Performance of the Riverside Energy Park in the context of the NPS framework

Report for the Greater London Authority

13th June 2019

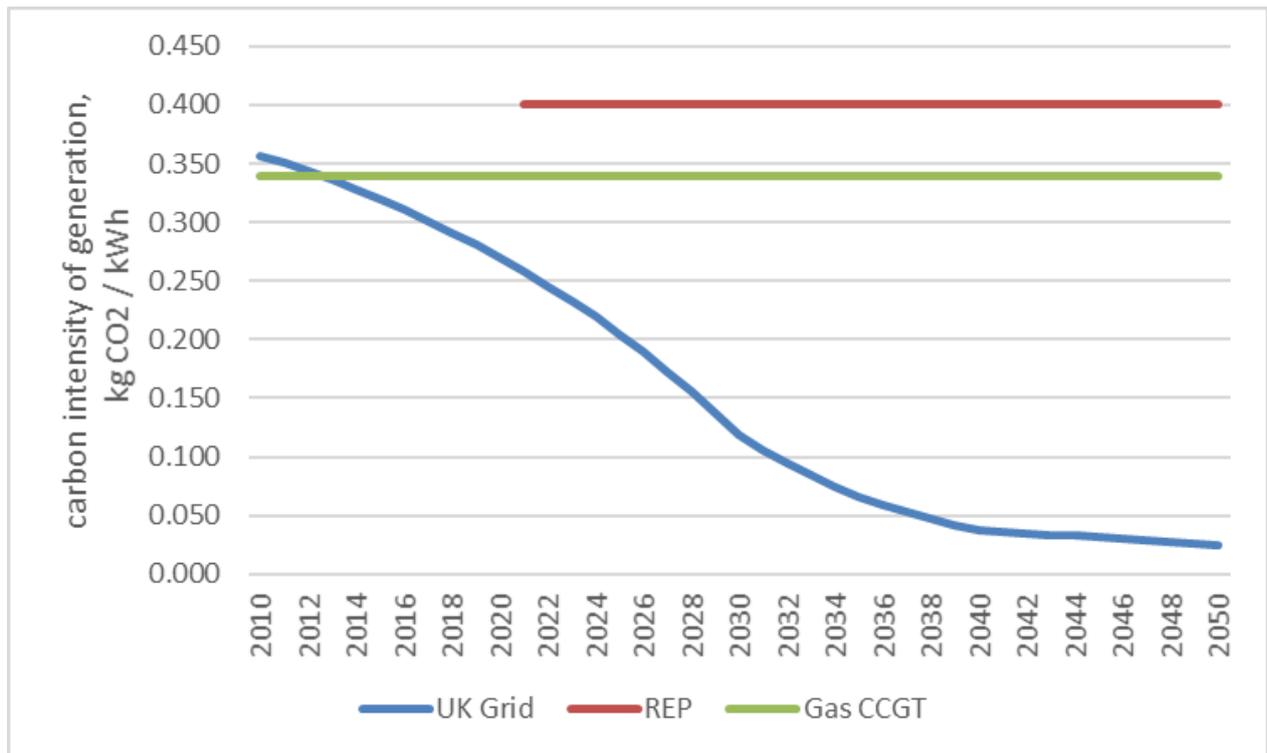
- 11) With the same composition, the facility is assumed to generate 998 kWh of electricity per tonne of waste treated, where only electricity is generated. Taking into account emissions associated with energy used at the facility, emissions resulting from energy generated at the facility are estimated to be around 0.4 kg CO₂e per kWh of electricity generated. This confirms that the facility will generate electricity that is of a higher carbon intensity than that generated by the UK electricity grid in 2010. By the time the facility is likely to start generating electricity, the carbon intensity of the grid will be much lower, in the order of 0.25 kg CO₂e per kWh electricity. Over time, the difference in carbon intensity between electricity generated at the REP and that of the grid will widen, as is shown in the graph below.

- 12) The above confirms that the REP plant cannot be considered to be a low carbon energy facility unless it is generating heat as well as electricity. Low carbon sources of generation on the grid include nuclear as well as renewables; electricity generated by the REP is clearly of a much higher carbon intensity than either of these sources. Indeed, the above data confirms that the REP is also of a higher carbon intensity than that of gas CCGT (for which Defra gives the carbon intensity as 0.34 kg CO₂ / kWh electricity). Thus all major sources of electricity likely to be used on the UK grid in the future are envisaged to be of a lower carbon intensity than that of the REP.
